From: Moniruzzaman, Asm
Sent: Monday, 1 March 2021 12:03 PM
To: AC, EPD Customer Services
Cc: TCCS_PC DACOORD
Subject: COMM: TCCS-202037593-S144B-3/65 MACGREGOR-01

DEVELOPMENT APPLICATION NO: 202037593-S144B

BLOCK: 3	SECTION: 65	SUBURB: MACGREGOR
-----------------	--------------------	--------------------------

Image 1

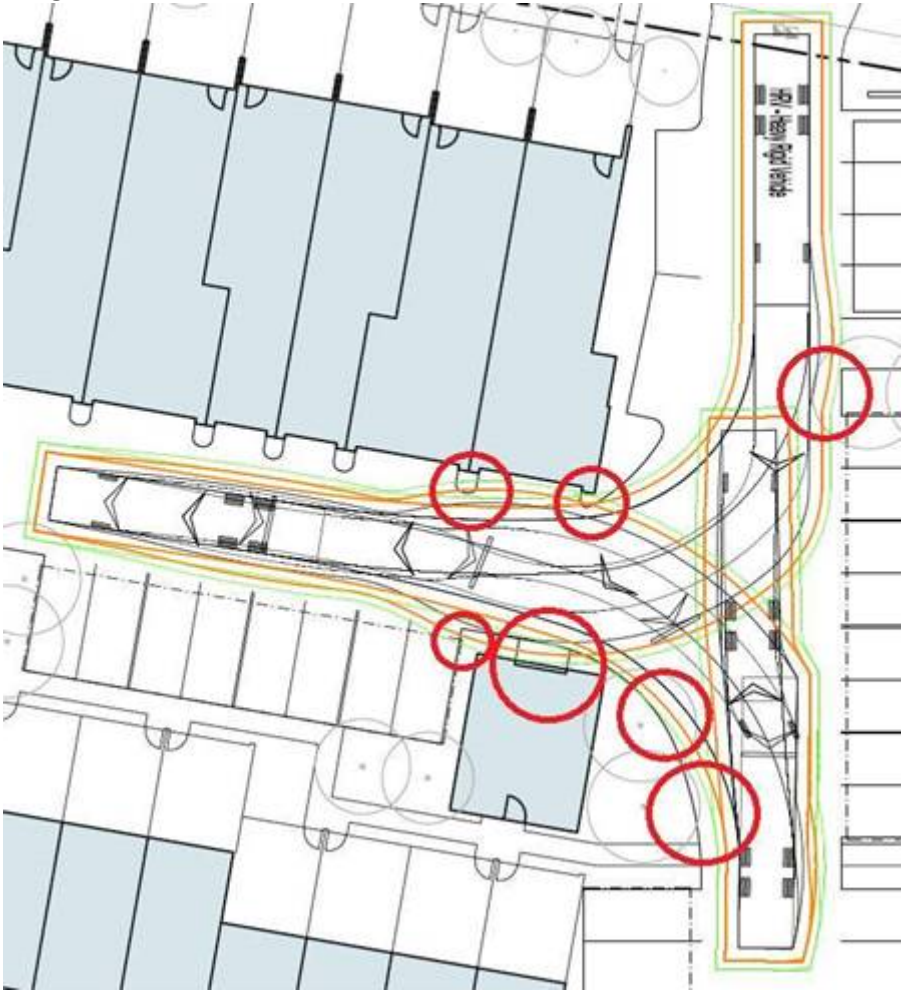
5. Vehicle Turning Path Plan 1 (Drawing 2201 Rev B).
 - A diagram showing Vehicle Tyre Path, Vehicle Body Outline and Body Clearance for the waste truck needs to be provided. It is not clear 600mm or 1,000 body clearance proposed.

- The truck turning templates moving in and out of the proposed verge crossing need to be provided.
 - It appears there are a few pinch points. For example, the waste truck's safety clearance is almost to the tree stump. The collection vehicle will interact with tree branches. The safety clearance interacts with a car parking space and buildings/planting areas. Demo 2 of drawing 2201-B demonstrates insufficient safety clearance in front of truck (images 1 and 2). AS2890.2 and A7.4 of the 2019 Waste Code states: "Circulation roadways must be designed to accommodate the swept path of the largest collection vehicles using the facility plus the specified clearance from the vehicle's body".

Image 2

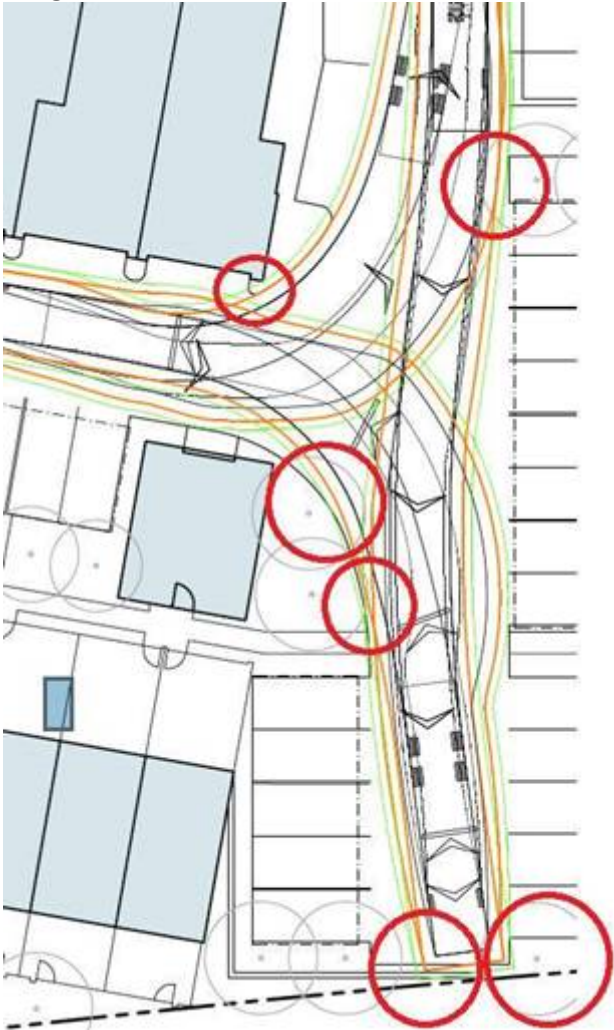
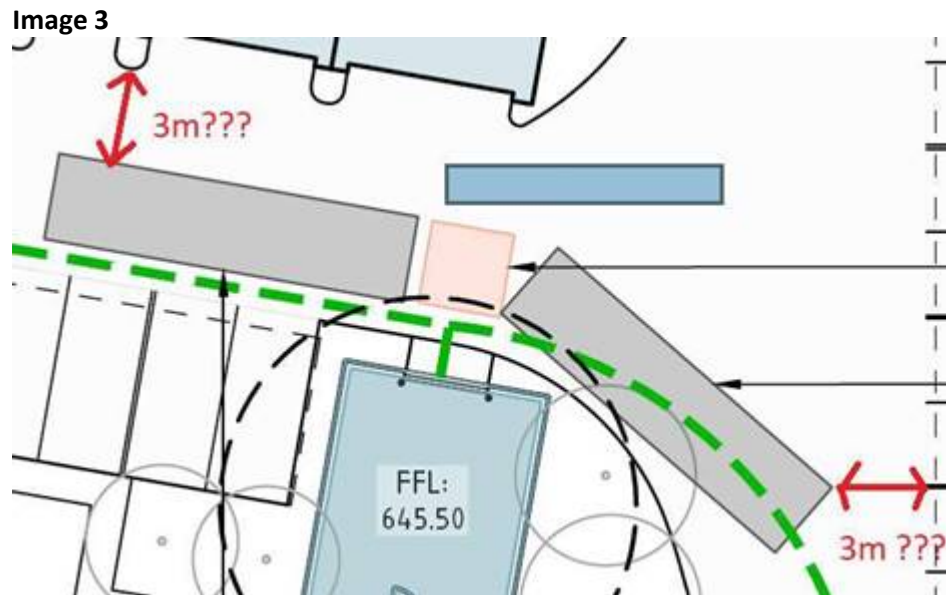
- AS2890.2 requires 3.0 metre road width for vehicles to pass truck. Has this requirement been met (see Image 3 below)?
6. Waste Management Details (Drawing 2311 Rev B).
